Subj: Texas Utilities Electric Company, et al.  
 (Comanche Peak Steam Electric Station,  
Units 1 and 2), Docket Nos. 50-445 and 50-446

# DESIGN/CONSTRUCTION SIGNIFICANT DEFICIENCY ANALYSIS REPORT

To R. G. Tolson Glen Rose, Texas October 21, 1982Subject COMANCHE PEAK STEAM ELECTRIC STATION  
SDAR CP-82-12  
PIPE WHIP RESTRAINT UNACCEPTABLE WELDS  
REF: TUQ-1419

To M.R. McBay - Engineering Manager Glen Rose, Texas November 24, 1982Subject COMANCHE PEAK STEAM ELECTRIC STATION  
PIPE WHIP RESTRAINT UNACCEPTABLE WELDS  
SDAR-CP-82-12  
NCR-M-82-01589

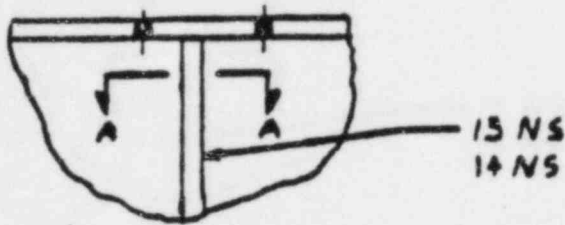
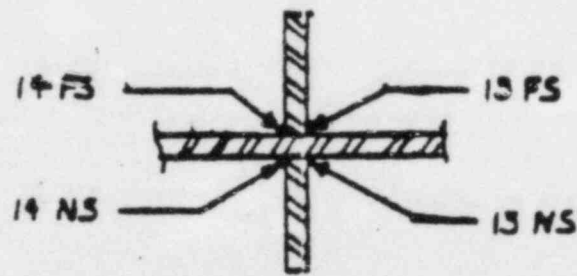
- 1) DEPTH OF UNDERCUT NOT GIVEN ON ALL UC DEFINED ON SHEET  
2 TO 16.
- 2) CLARIFICATION BY SKETCH NEEDED ON 'NS' AND 'FS' FILLET  
WELDS AT "CROSS" JOINTS WITH 4 FILLET WELDS. THIS  
PROBLEM ARISES IN ALL SHEETS.
- 3) CONFIRM THAT NUMBER PRECEEDING THE ASSEMBY NO. IS NOT  
RELEVANT.
- 4) FOR D-138-1-D, PROVIDE DETAILS OF UNDERFILL FOR THE  
FULL PENETRATION WELD.
- 5) FOR D-138-1-D, THE WELD NO. 281 SHALL BE 221.  
PLEASE CONFIRM.
- 6) FOR D-140-1-C WELD 1 AND D-140-1-B WELD 2, PLEASE  
PROVIDE THE ACTUAL LOCATION OF 'UC' AND 'IF' DUE TO  
THE CRITICAL NATURE OF THE AREA.

7) PROVIDE MORE INFORMATION ON THE FOLLOWING AREAS:

This letter is to clarify items 1 through 9 on the referenced GTT letter.

1. See attached sheets for depth of under cut.
2. See attached sketch for clarification of notation for fillet welds at "cross" joints.
3. The number preceding the assembly number is a number assigned on site and is not revelant for your purposes.
4. See attached sheets for depth of underfill.
5. The weld number is 221 instead of 281.
6. See attached sheets for locations.
7. The under-cut depth is given on the attached sheets, and the IF, IP and linear indication will have to be evaluated by exploratory grinding.
8. Weld No. 4FS is to be changed to 12FS and 1/4 fillet weld may be used for evaluation.
9. The BMD and unacceptable BM repair will have to be reviewed. The locations of the welds will be furnished on TWX-14,067.
